RE: Bernheim - Change Order 28- Added Concrete Plazas and Omission of Gravel **DC**

PROJECT: *(Name and address)*
Bernheim Middle School Renovation
700 Audubon Drive, Shepherdsville, KY
40165

CHANGE ORDER INFORMATION:
Change Order Number: 028
Date: September 30, 2024

COURTYARD PAVING
 BERNHEIM MIDDLE SCHOOL
 RFP # 26

RFP #26
 SHEET
 1 OF 3

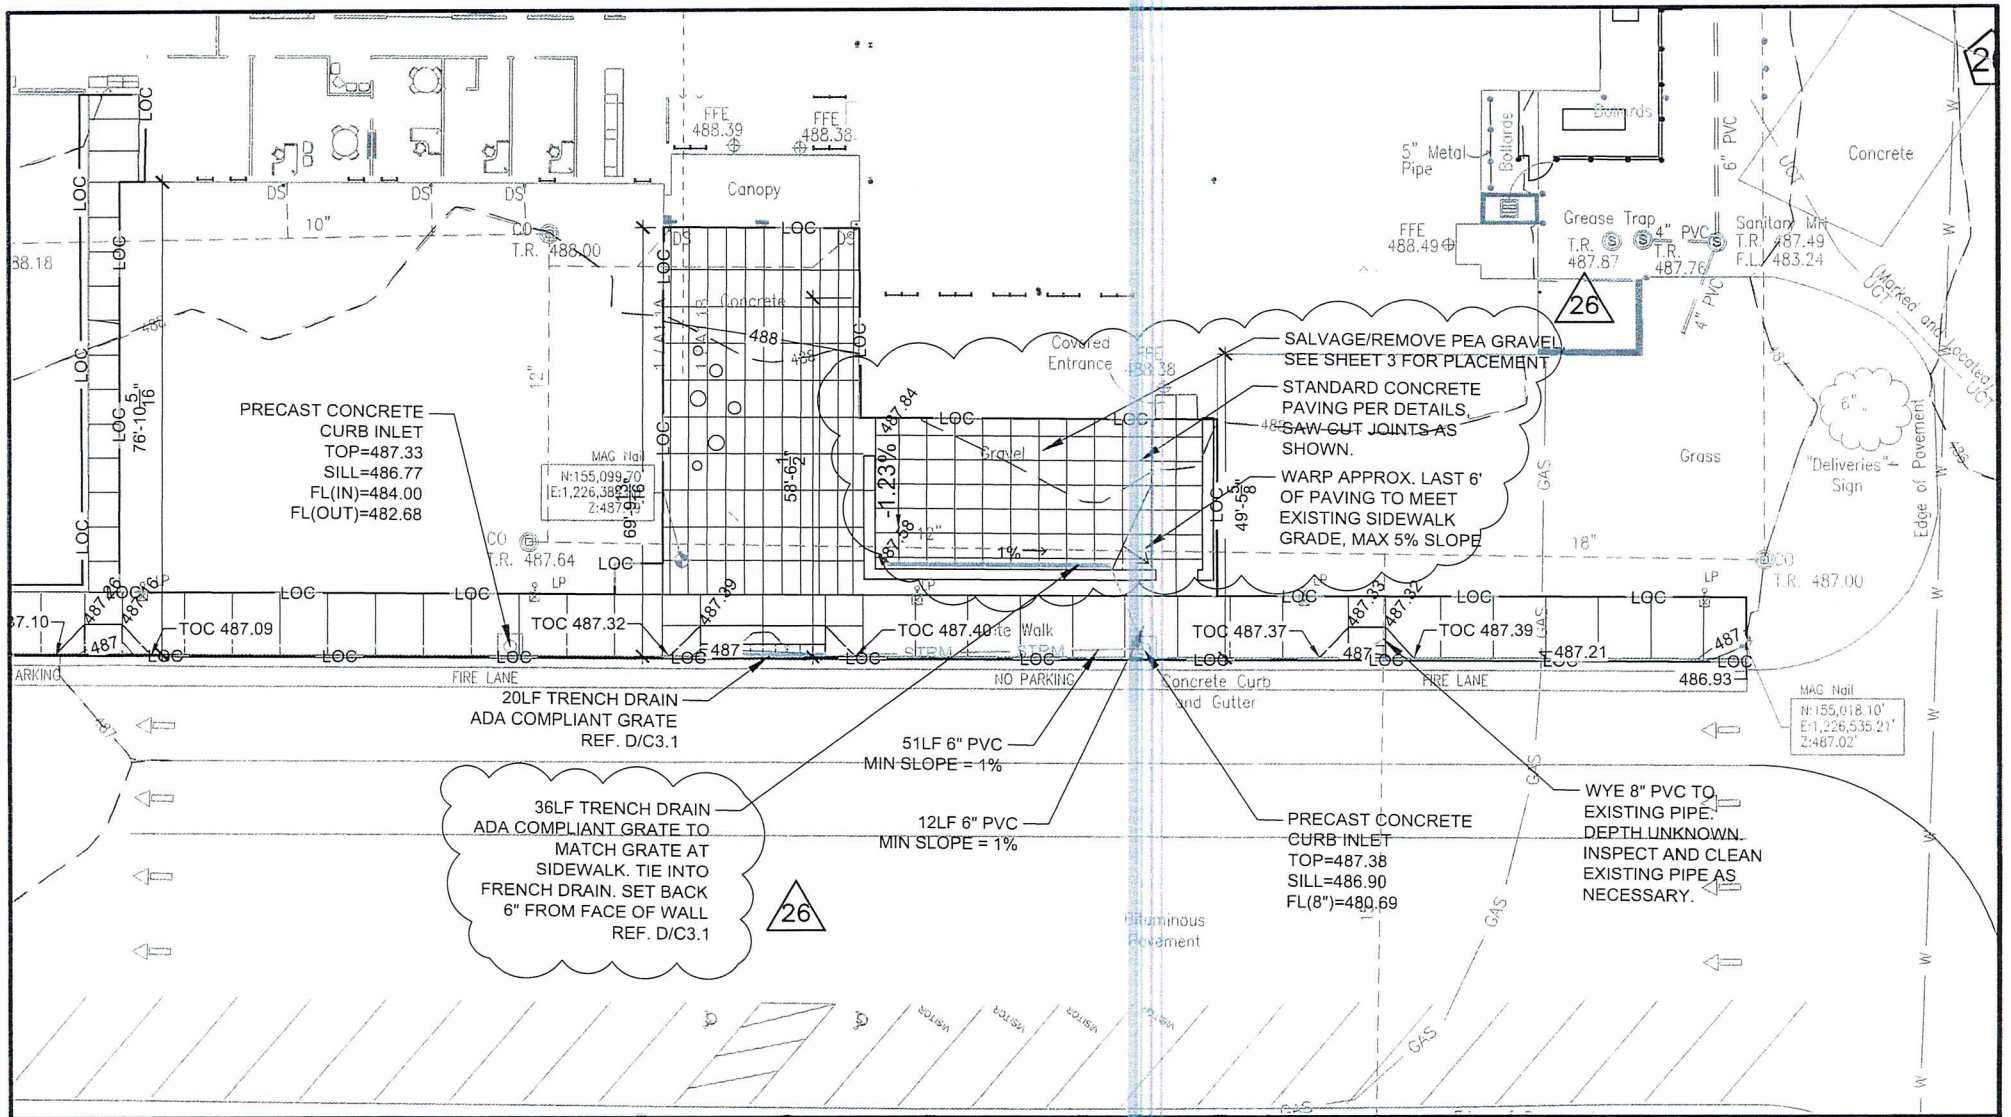
1. Cafeteria plaza (Sheet 1): Replace pea gravel area at cafeteria plaza with standard concrete paving, per the plan sheet. Provide 36LF ADA compliant trench drain along wall, to replace currently installed french drain and tie-into connection back to curb inlet as shown. Salvage pea gravel for use on site. Omit three (3) trees and provide Credit.
2. Science Plaza (Sheet 2): Remove pea gravel and salvage. Demo existing curb and pad for rain barrel. Install standard concrete pavement per plan.
3. Outdoor classroom (Sheet 3): Place salvaged pea gravel in lieu of mulch once finished grade has been established. Provide credit for un-installed mulch.

20LF TRENCH DRAIN
 ADA COMPLIANT GRATE
 REF. D/C3.1

36LF TRENCH DRAIN
 ADA COMPLIANT GRATE TO
 MATCH GRATE AT
 SIDEWALK. TIE INTO
 FRENCH DRAIN. SET BACK
 6" FROM FACE OF WALL
 REF. D/C3.1

SALVAGE/REMOVE PEA GRAVEL
 SEE SHEET 3 FOR PLACEMENT
 STANDARD CONCRETE
 PAVING PER DETAILS,
 SAW-CUT JOINTS AS
 SHOWN.
 WARP APPROX. LAST 6'
 OF PAVING TO MEET
 EXISTING SIDEWALK
 GRADE, MAX 5% SLOPE

WYE 8" PVC TO
 EXISTING PIPE.
 DEPTH UNKNOWN.
 INSPECT AND CLEAN
 EXISTING PIPE AS
 NECESSARY.

REF. SHEET C1.1		RFP #26 SHEET 2 OF 3
SCALE - 1:20		
DATE: 8/16/24	DRAWN BY: PT

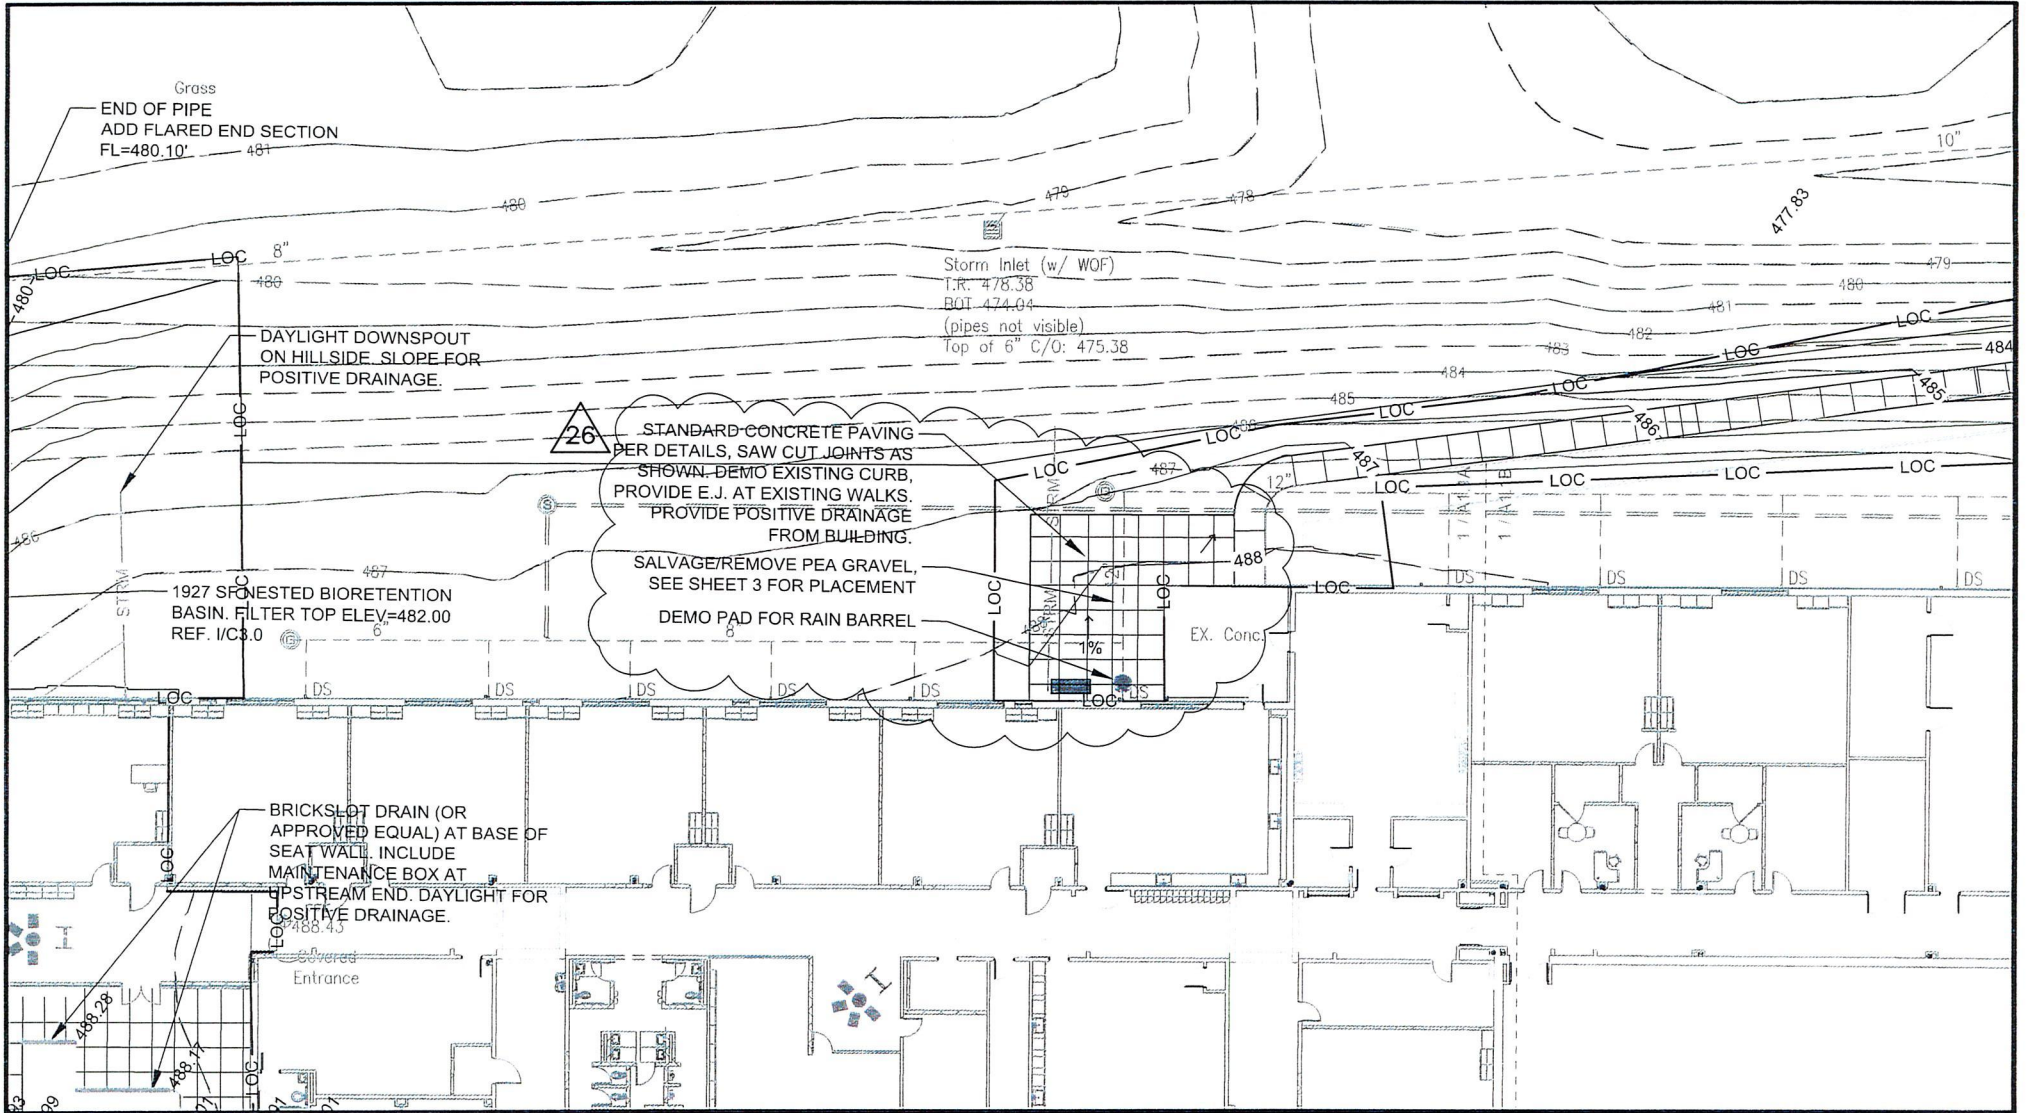
26 STANDARD CONCRETE PAVING PER DETAILS, SAW CUT JOINTS AS SHOWN. DEMO EXISTING CURB, PROVIDE E.J. AT EXISTING WALKS. PROVIDE POSITIVE DRAINAGE FROM BUILDING. SALVAGE/REMOVE PEA GRAVEL, SEE SHEET 3 FOR PLACEMENT. DEMO PAD FOR RAIN BARREL

DAYLIGHT DOWNSPOUT ON HILLSIDE SLOPE FOR POSITIVE DRAINAGE.

BRICKSLOT DRAIN (OR APPROVED EQUAL) AT BASE OF SEAT WALL. INCLUDE MAINTENANCE BOX AT UPSTREAM END. DAYLIGHT FOR POSITIVE DRAINAGE.

RFP #26
 SHEET
 1 OF 3

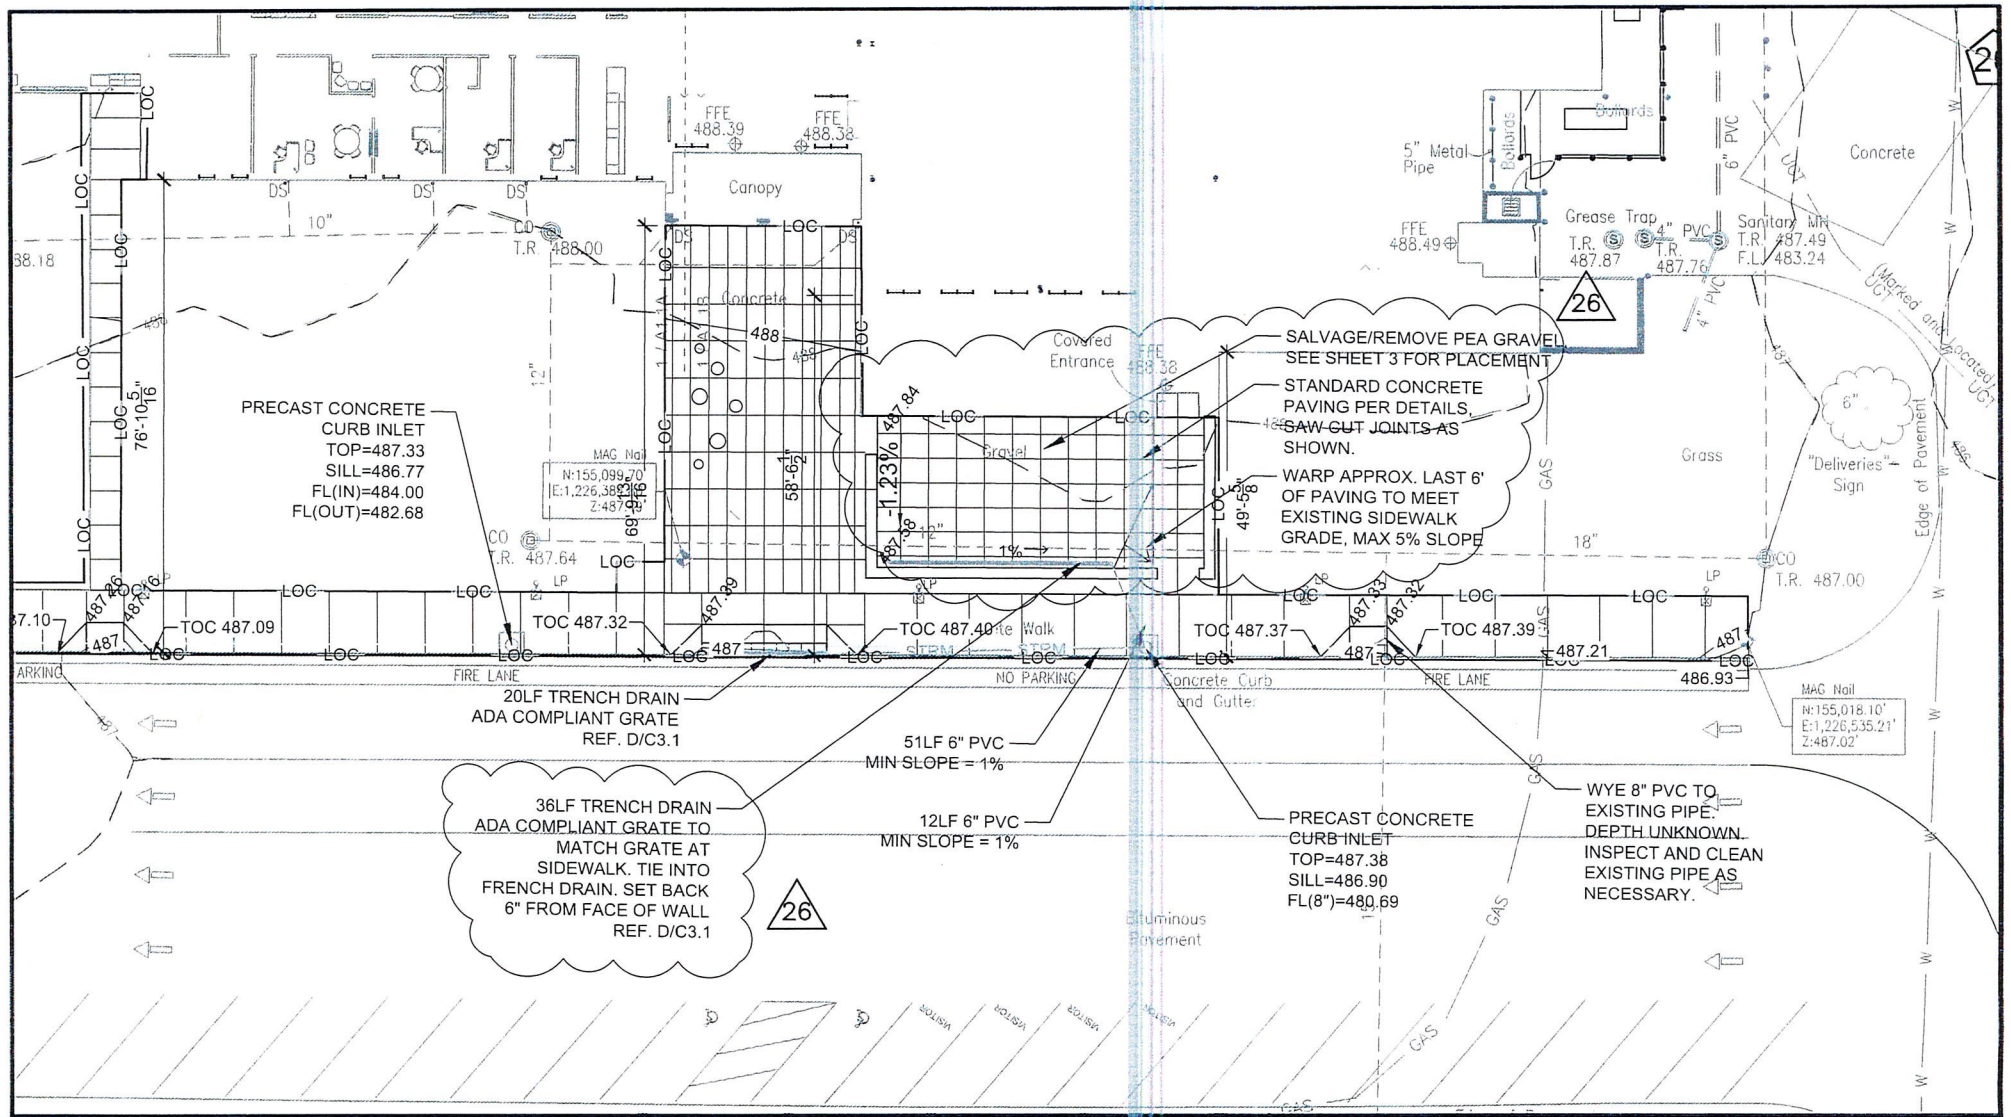
1. Cafeteria plaza (Sheet 1): Replace pea gravel area at cafeteria plaza with standard concrete paving, per the plan sheet. Provide 36LF ADA compliant trench drain along wall, to replace currently installed french drain and tie-into connection back to curb inlet as shown. Salvage pea gravel for use on site. Omit three (3) trees and provide Credit.
2. Science Plaza (Sheet 2): Remove pea gravel and salvage. Demo existing curb and pad for rain barrel. Install standard concrete pavement per plan.
3. Outdoor classroom (Sheet 3): Place salvaged pea gravel in lieu of mulch once finished grade has been established. Provide credit for un-installed mulch.

36LF TRENCH DRAIN
 ADA COMPLIANT GRATE TO
 MATCH GRATE AT
 SIDEWALK. TIE INTO
 FRENCH DRAIN. SET BACK
 6" FROM FACE OF WALL
 REF. D/C3.1

20LF TRENCH DRAIN
 ADA COMPLIANT GRATE
 REF. D/C3.1

WYE 8" PVC TO EXISTING PIPE. DEPTH UNKNOWN. INSPECT AND CLEAN EXISTING PIPE AS NECESSARY.

SALVAGE/REMOVE PEA GRAVEL
 SEE SHEET 3 FOR PLACEMENT
 STANDARD CONCRETE PAVING PER DETAILS. SAW-CUT JOINTS AS SHOWN.
 WARP APPROX. LAST 6' OF PAVING TO MEET EXISTING SIDEWALK GRADE, MAX 5% SLOPE

RFP #26
 SHEET
 2 OF 3

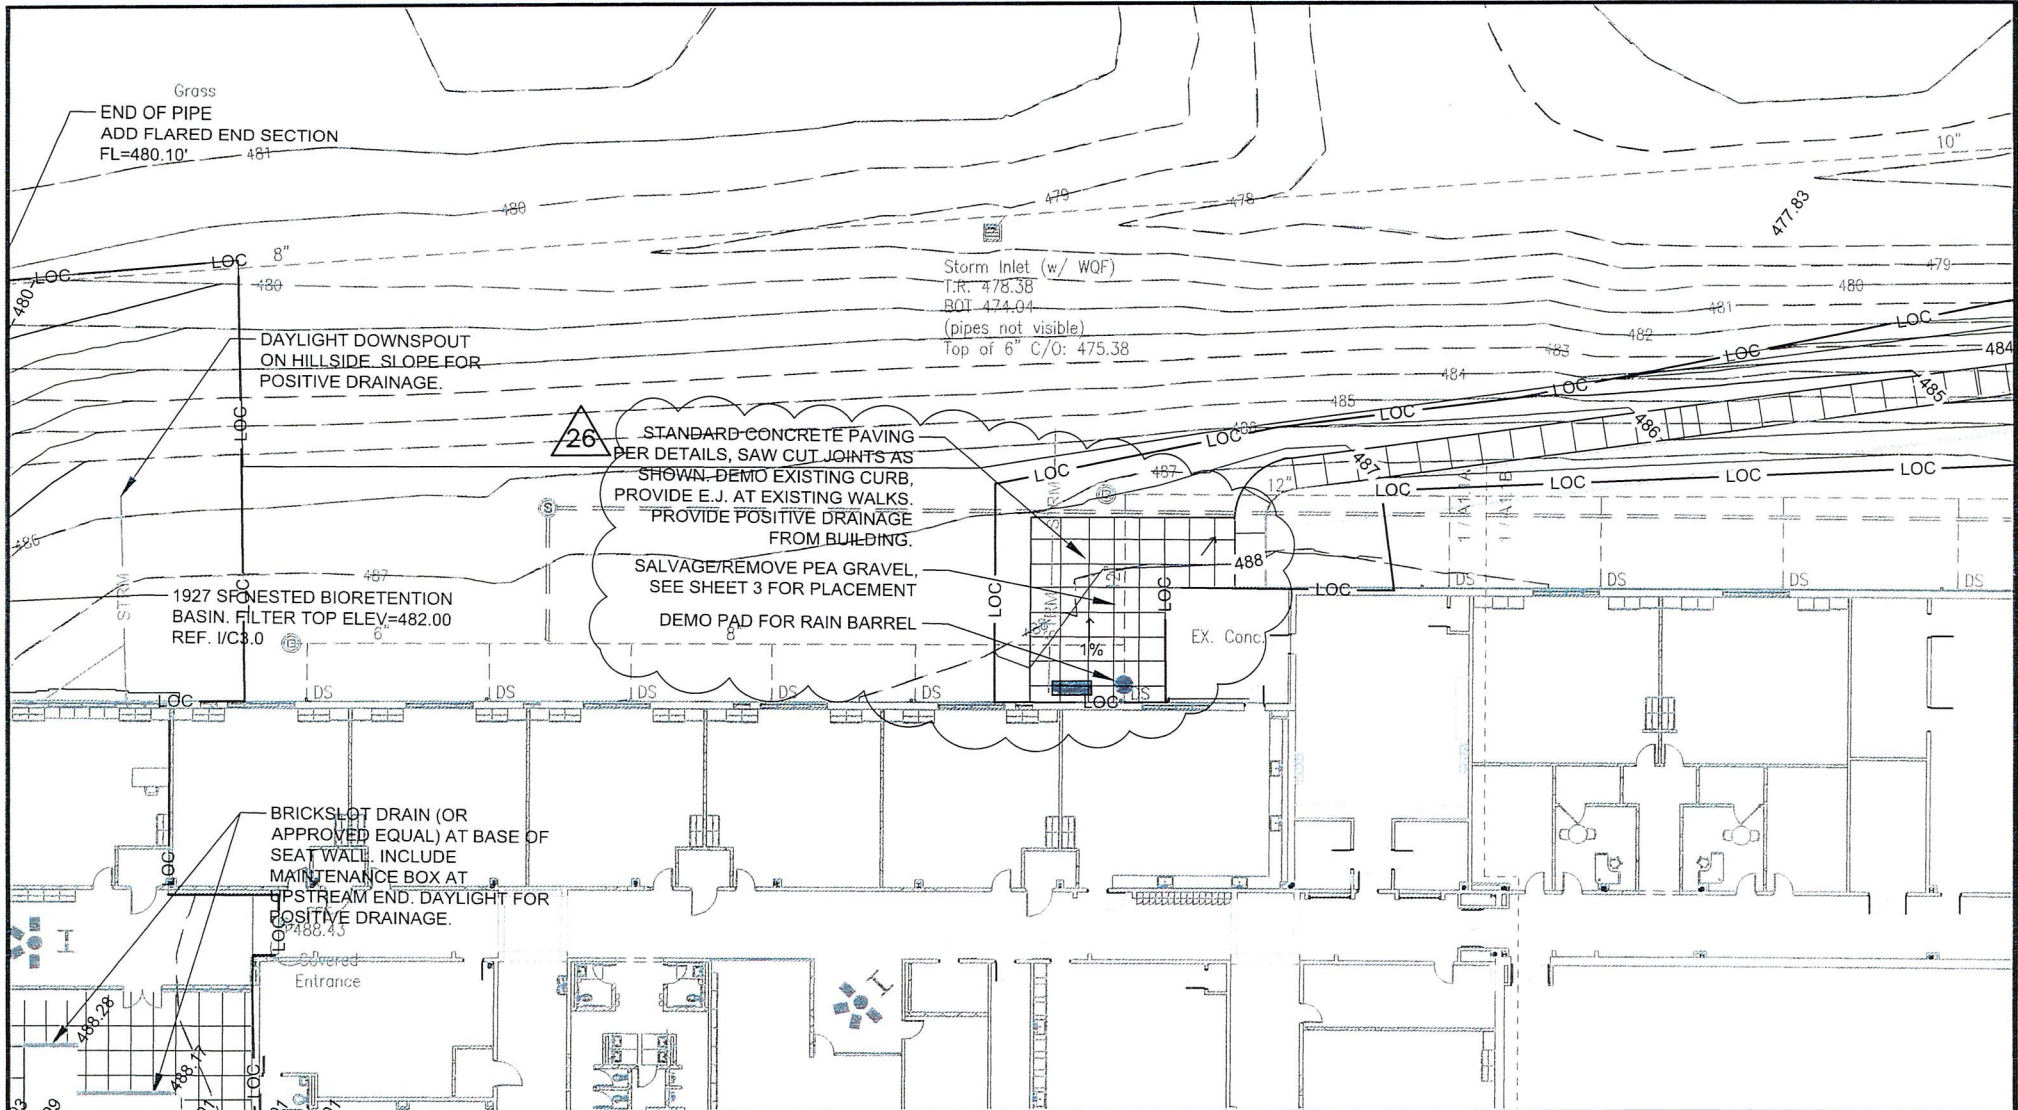
Grass
 END OF PIPE
 ADD FLARED END SECTION
 FL=480.10'

DAYLIGHT DOWNSPOUT
 ON HILLSIDE SLOPE FOR
 POSITIVE DRAINAGE.

26
 STANDARD CONCRETE PAVING
 PER DETAILS, SAW CUT JOINTS AS
 SHOWN. DEMO EXISTING CURB,
 PROVIDE E.J. AT EXISTING WALKS.
 PROVIDE POSITIVE DRAINAGE
 FROM BUILDING.
 SALVAGE/REMOVE PEA GRAVEL,
 SEE SHEET 3 FOR PLACEMENT
 DEMO PAD FOR RAIN BARREL

BRICKSLOT DRAIN (OR
 APPROVED EQUAL) AT BASE OF
 SEAT WALL. INCLUDE
 MAINTENANCE BOX AT
 UPSTREAM END. DAYLIGHT FOR
 POSITIVE DRAINAGE.
